RE: 071825_VA Credit Union, Blacksburg, VA - BMEP 1st rev

Virginia Credit Union Branch renovation 202 N. Main St.

A. Comments & Responses

Itemized below are responses to the review comments for project #071825, dated 8/13/25. Replies to comments are listed in the order in which they appear within the reviewed and marked up PDF "071825_VA Credit Union, Blacksburg, VA - BMEP 1st rev" from top to bottom of each sheet.

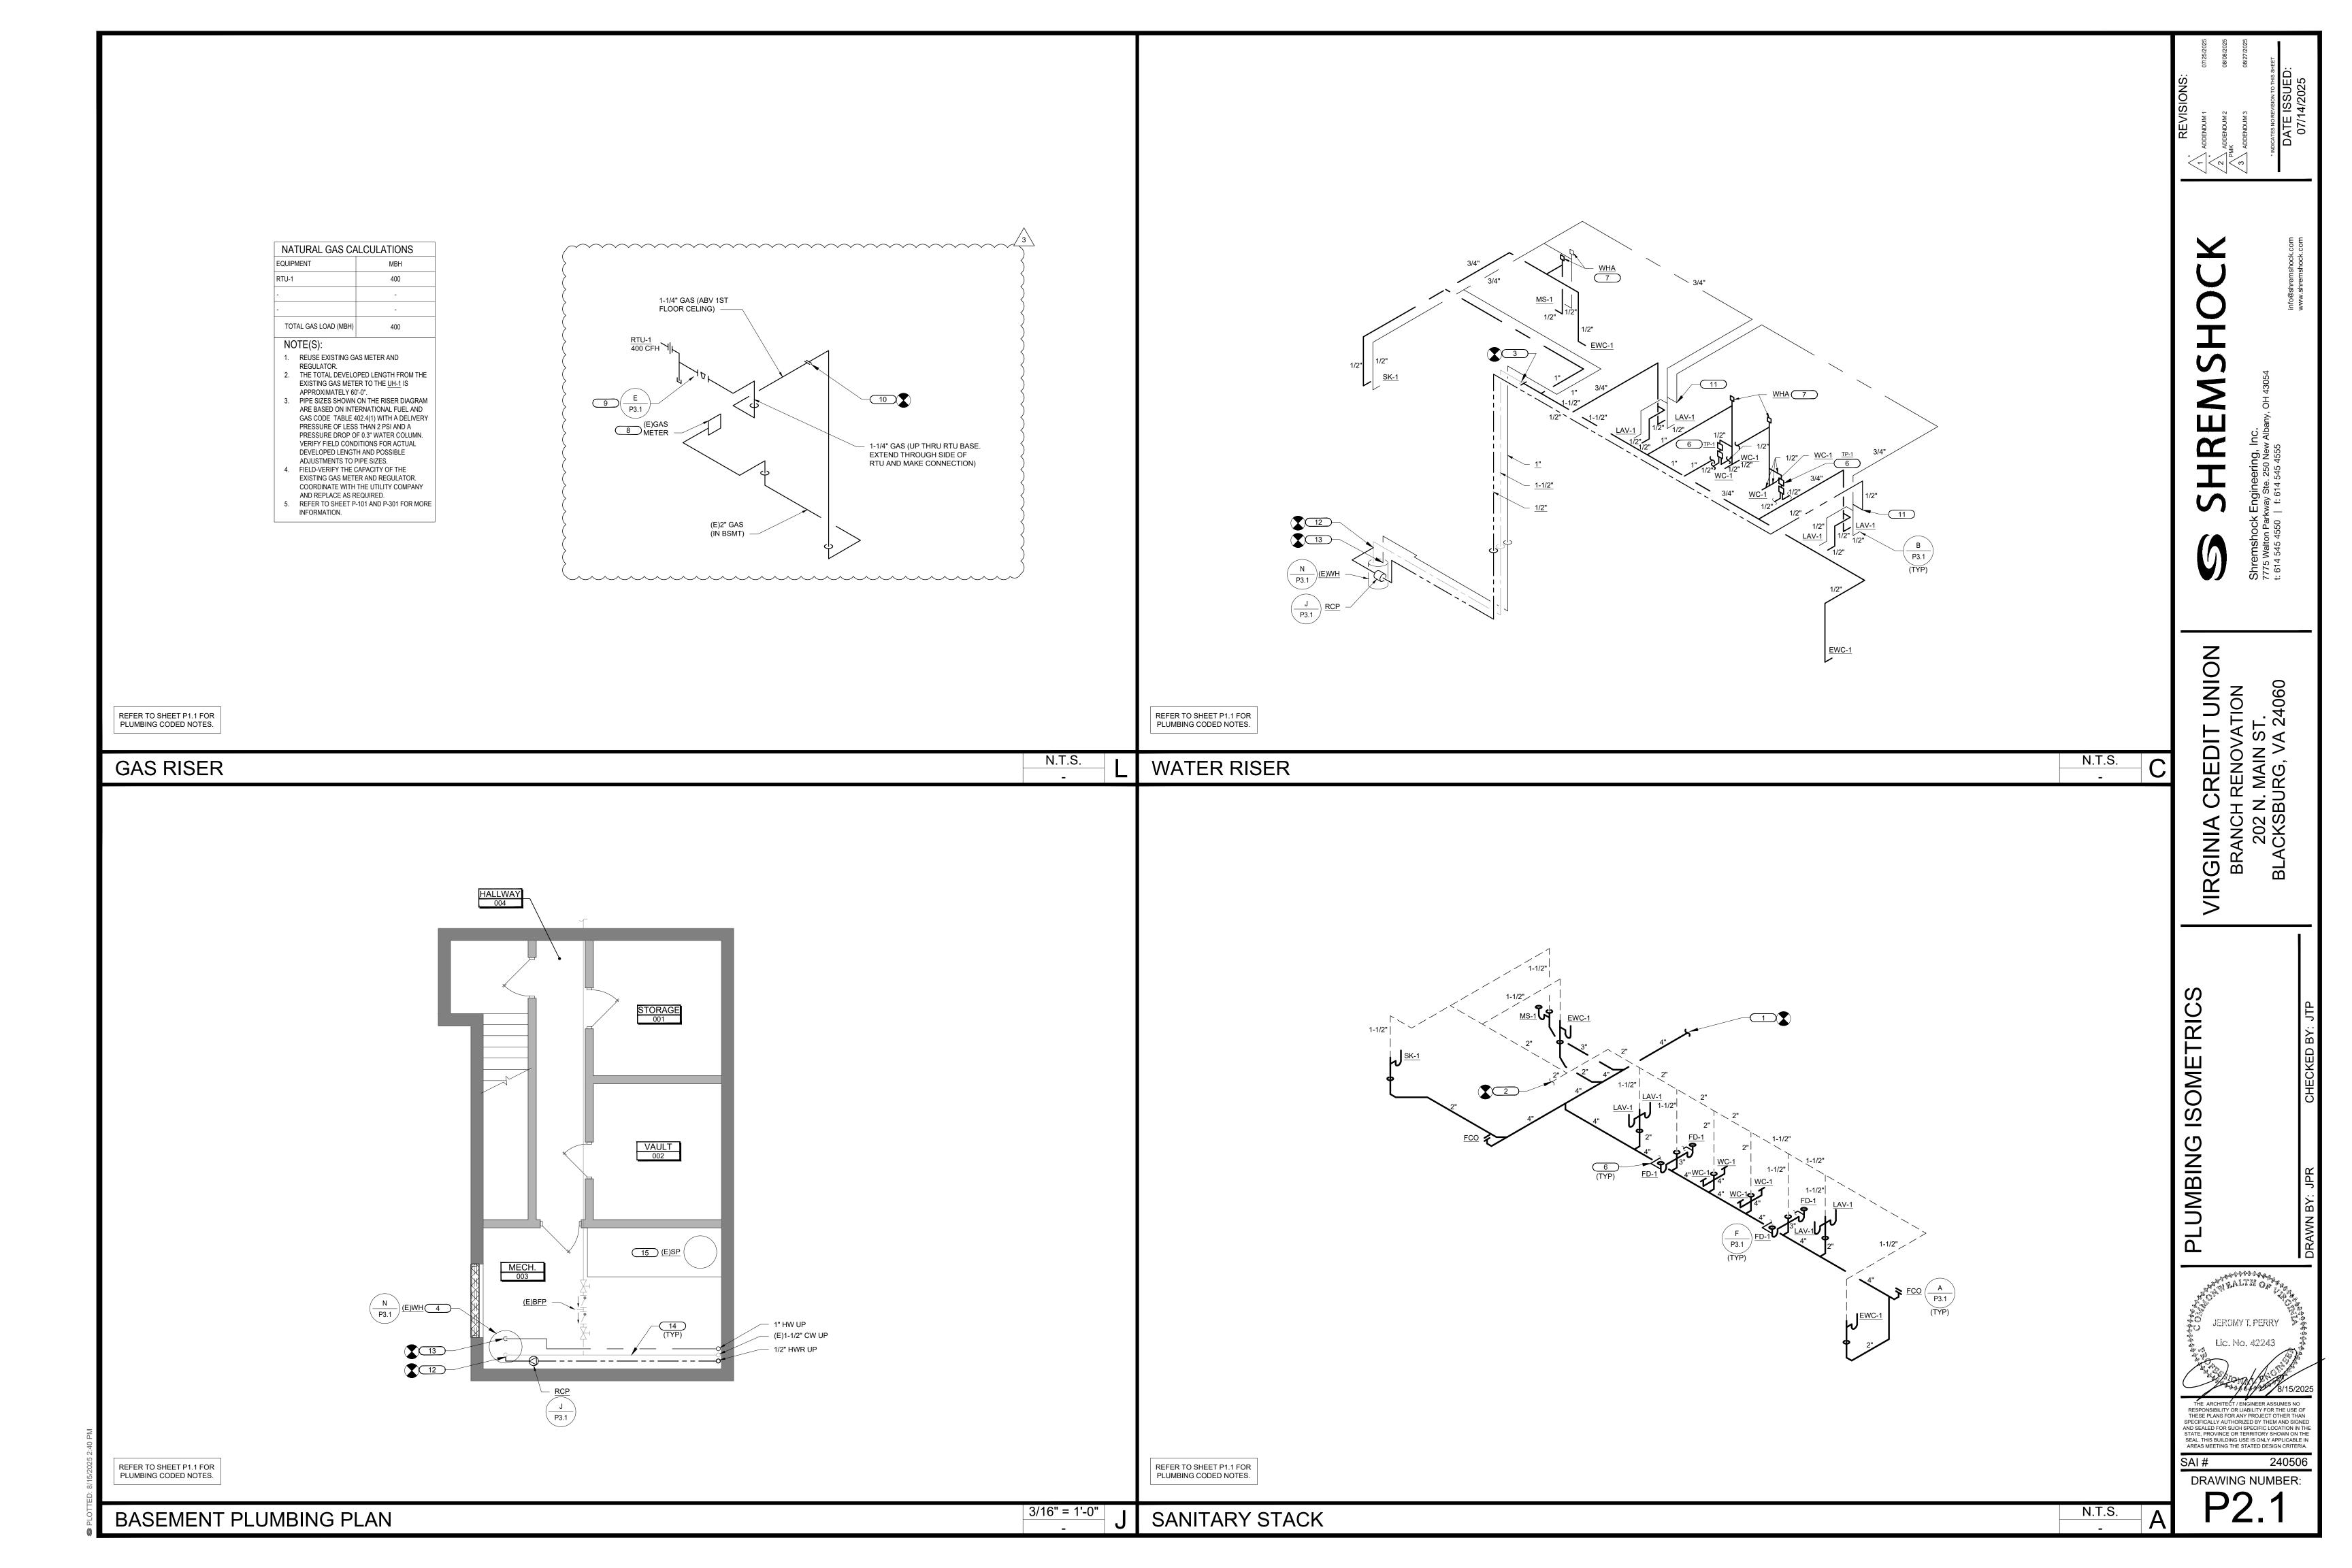
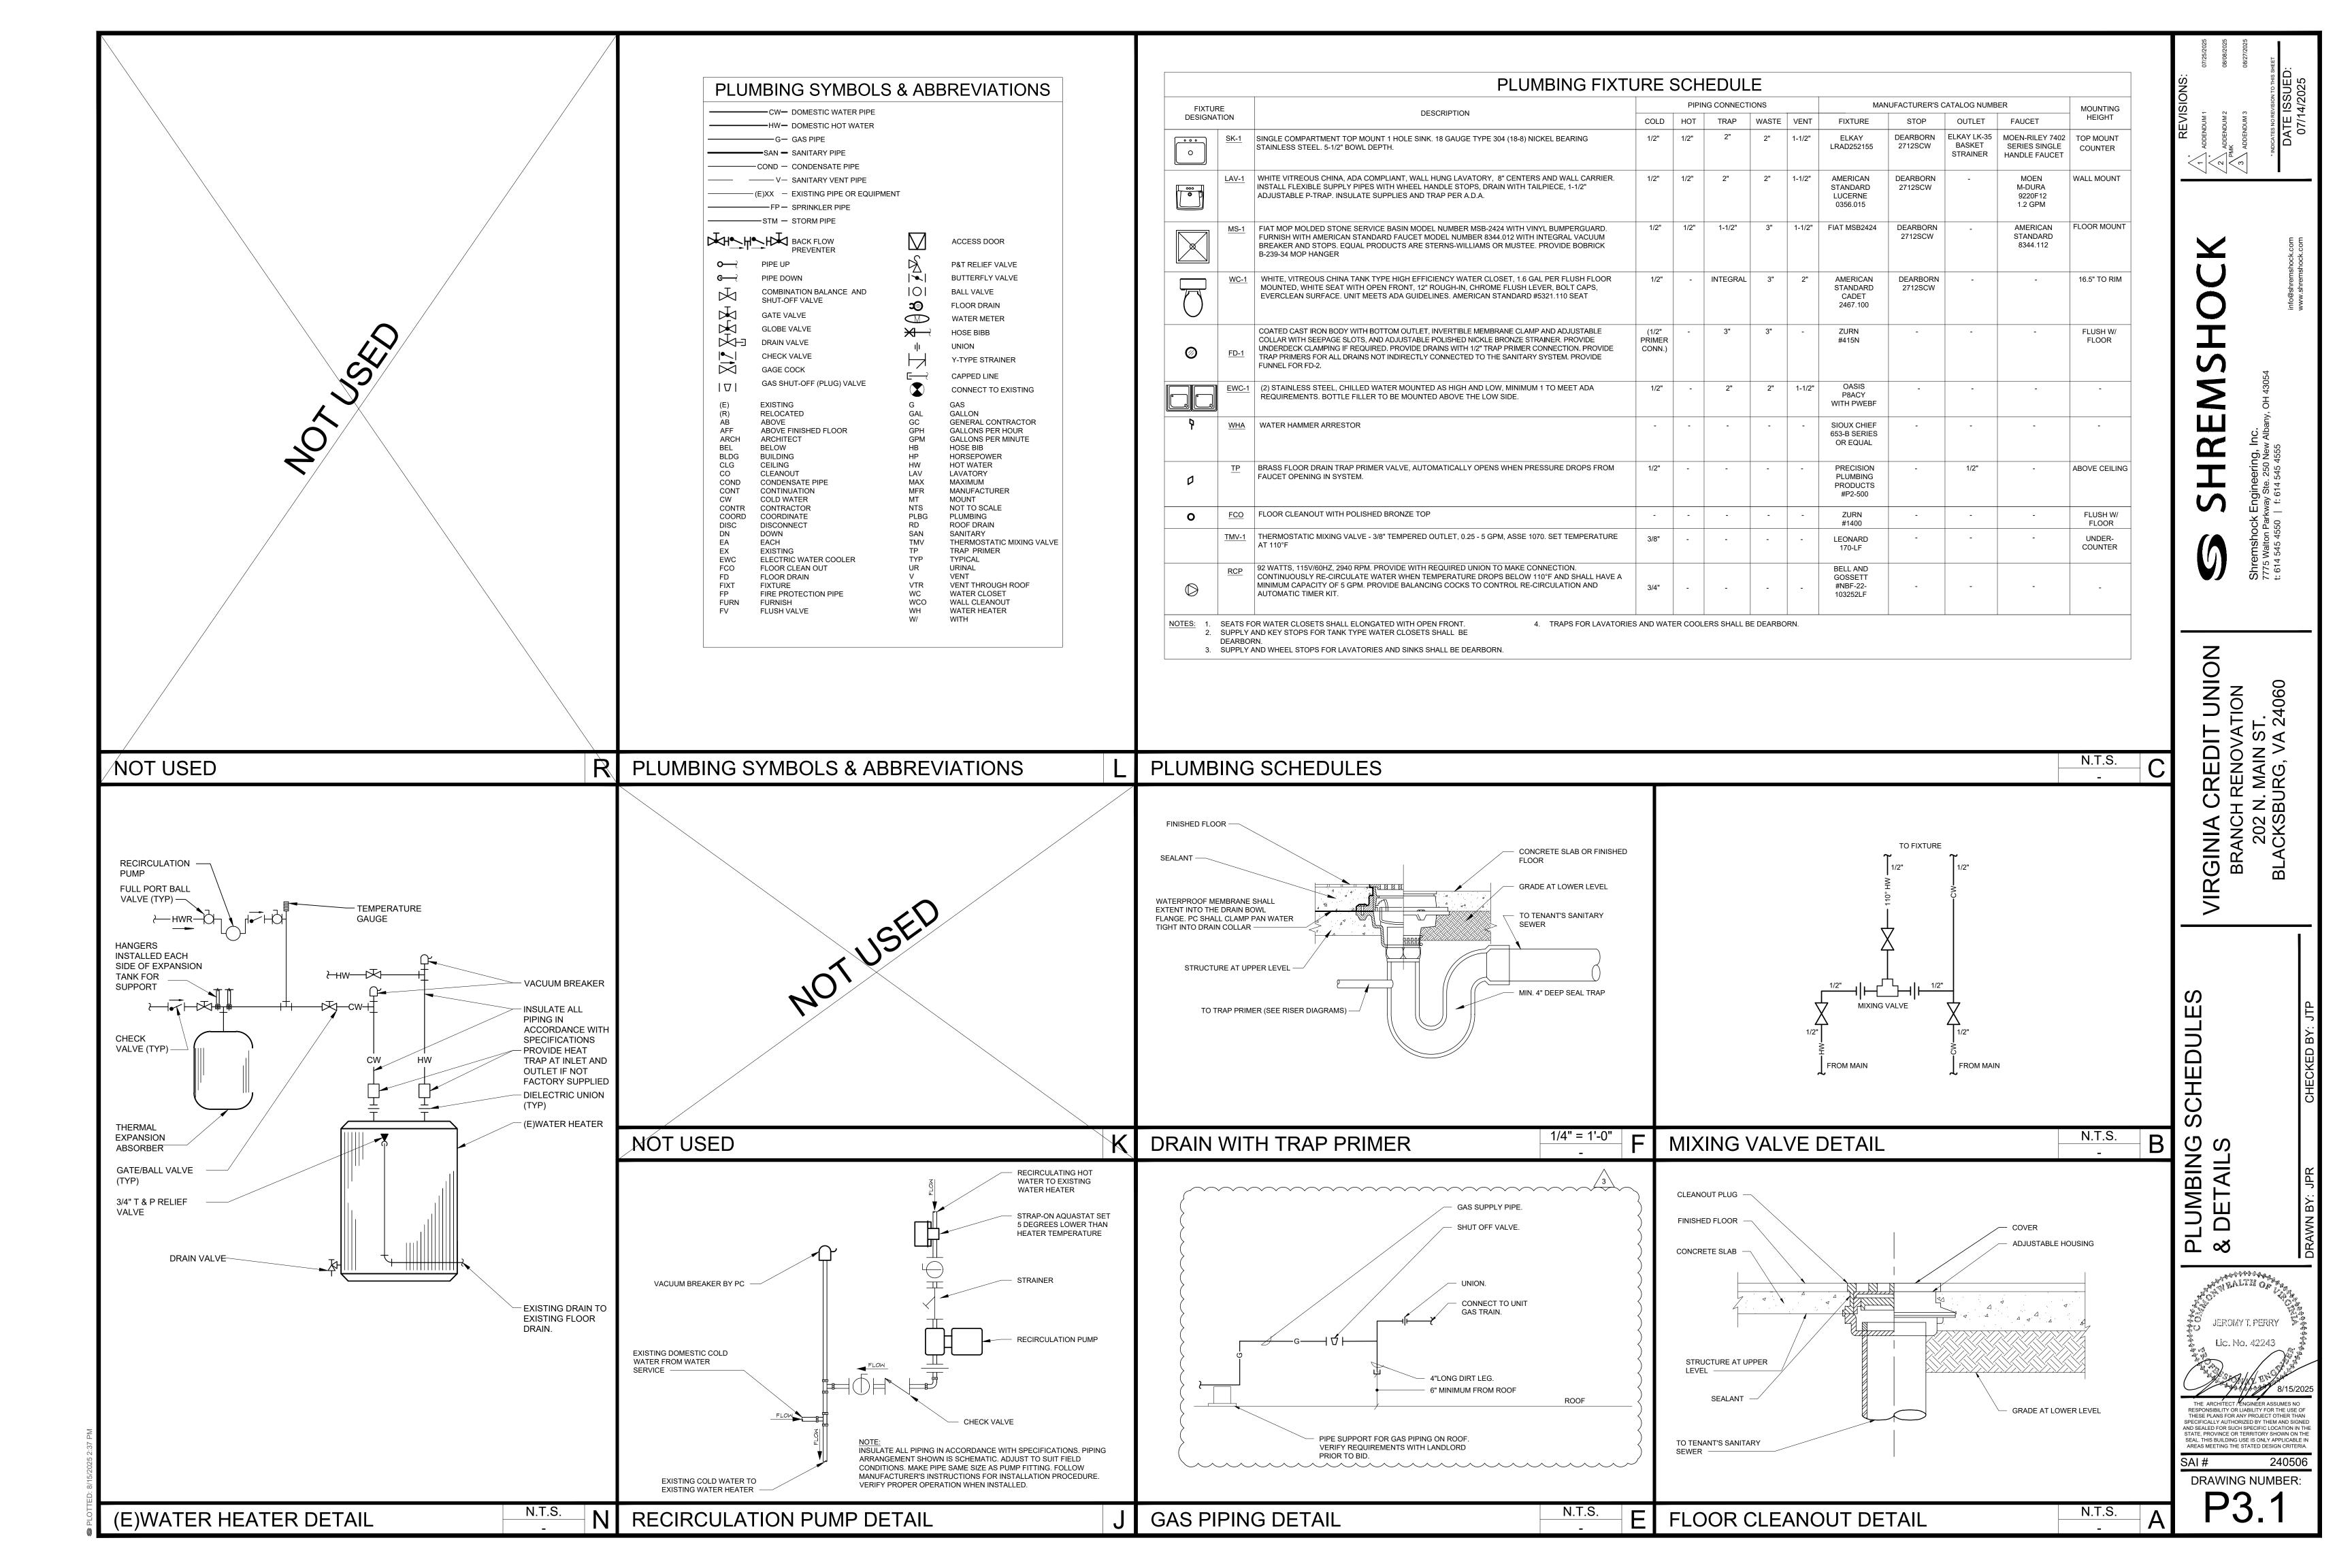
11. Reviewer's Comment (Sheet E4.1):

Add fixture type 'EX1' to schedule indicate battery backup. VBC 1008.3

Response:

Fixture 'EX1' added to lighting fixture schedule and specified with 90-minute battery backup.

A. Lighting Fixture Schedule: Added fixture type 'EX1' with 90-minute battery backup.
